# Sumter City-County Planning Commission

## MSP-12-08/HCPD-12-06, N. Pike West & Farmers Telephone Rd. – SCE&G Gas Operations Center (City)

### I. THE REQUEST

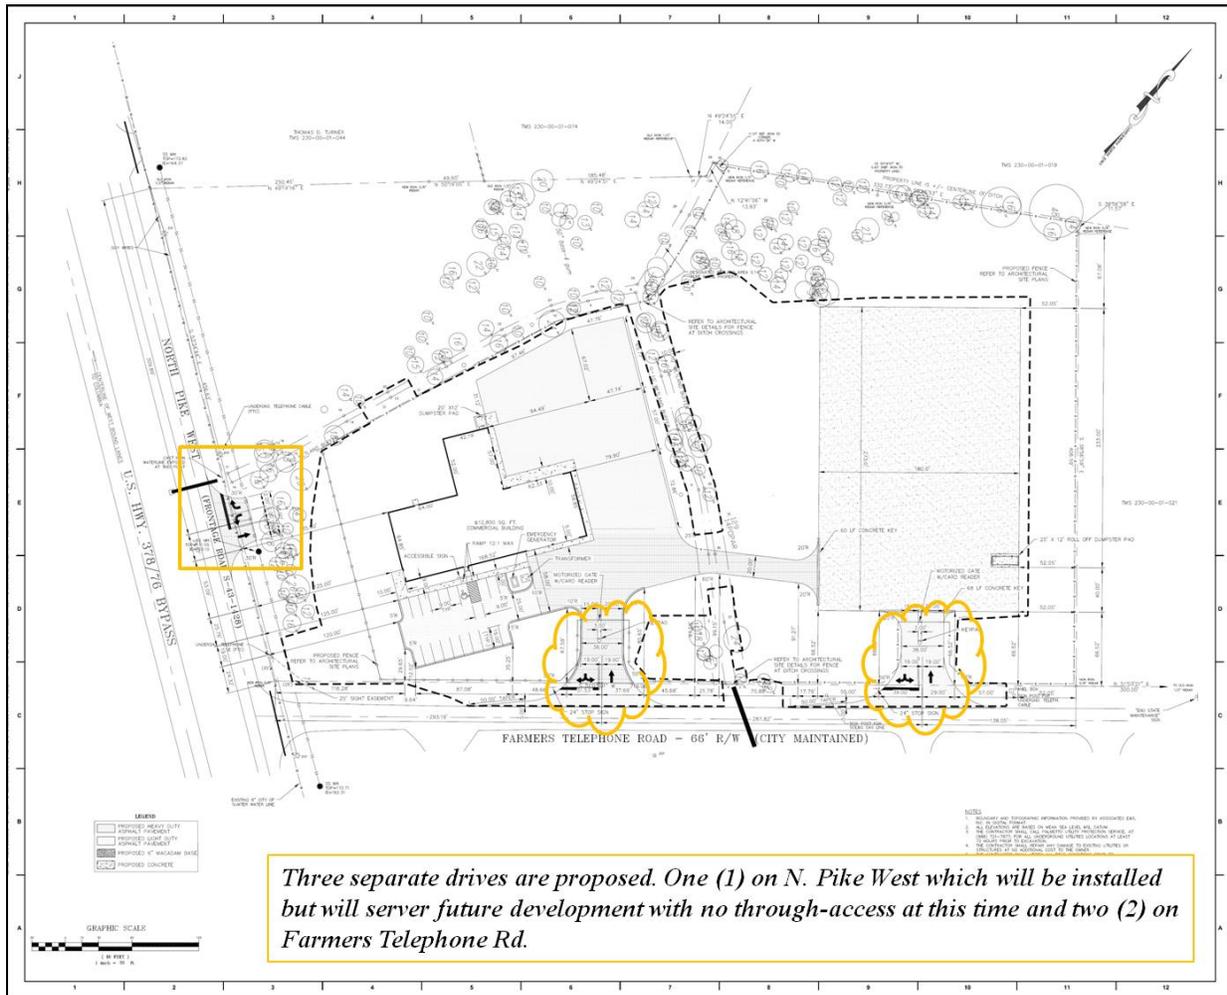
**Shown Above:** the black dotted line surrounding the landscaping on Farmers Telephone Rd. and N. Pike West is a simulated wrought iron fence.

All trees including the Crepe Myrtle and Bald Cypress must have a minimum 2” caliper at time of planting.

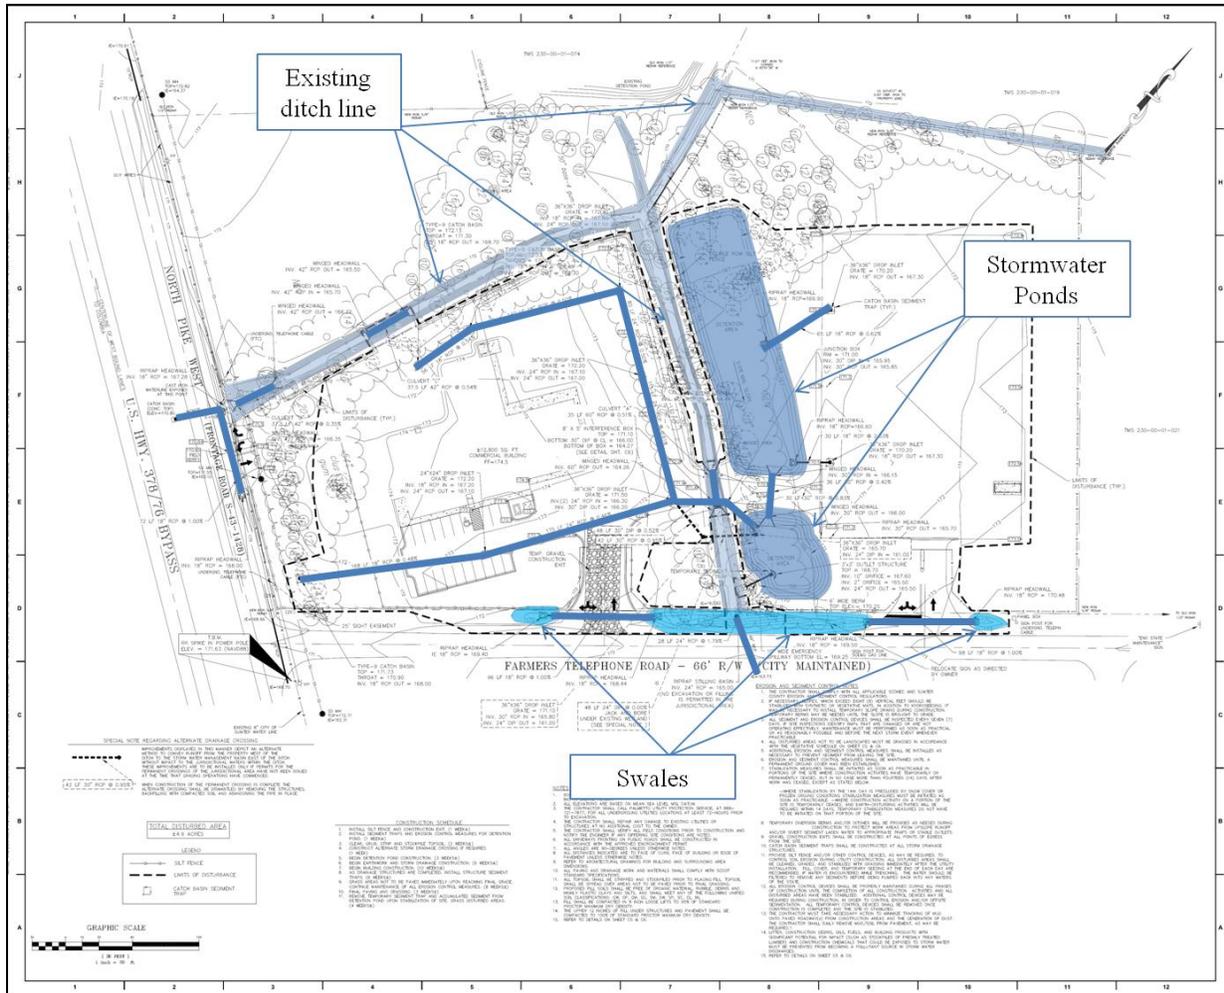
This project does not meet the threshold requirements for a formal traffic study. Three access drives are proposed for the site as shown in the graphic below.

Based on review by the Senior Transportation Planner and City Engineering, the access meets standards for spacing, throat length, width and turning radii. In addition, the drives meet corner clearance in accordance with the SC DOT ARMS Manual. The proposed development will not adversely impact the level of service on N. Pike West or Farmers Telephone Rd.

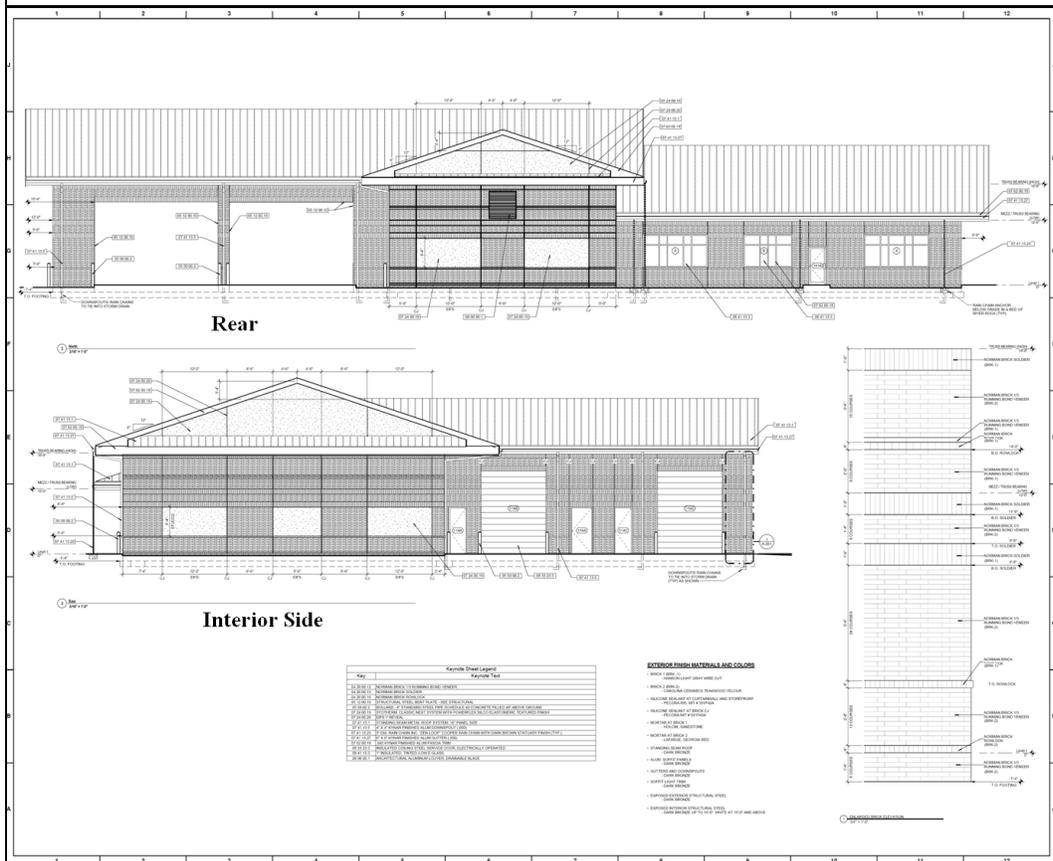
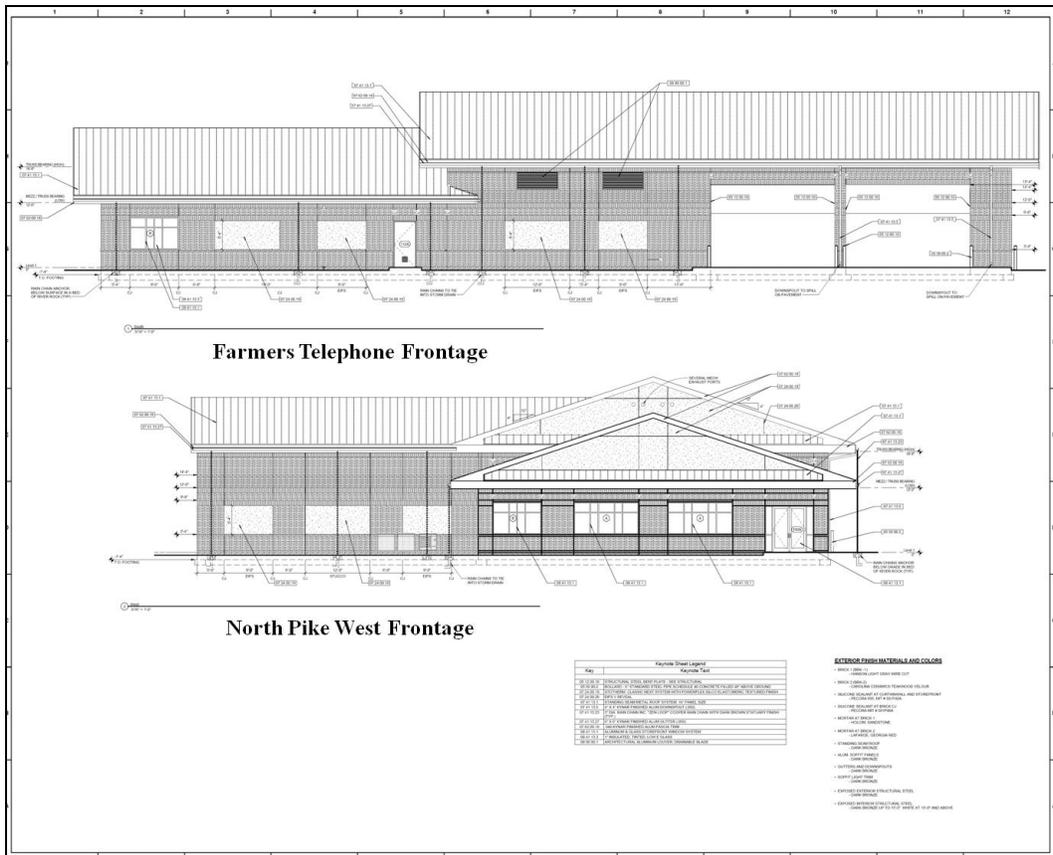
- a. *If a new commercial building is proposed, not more than sixty percent (60%) of the facade facing a street may be glass or reflective materials;*

The proposed structure does not exceed the 60% threshold.
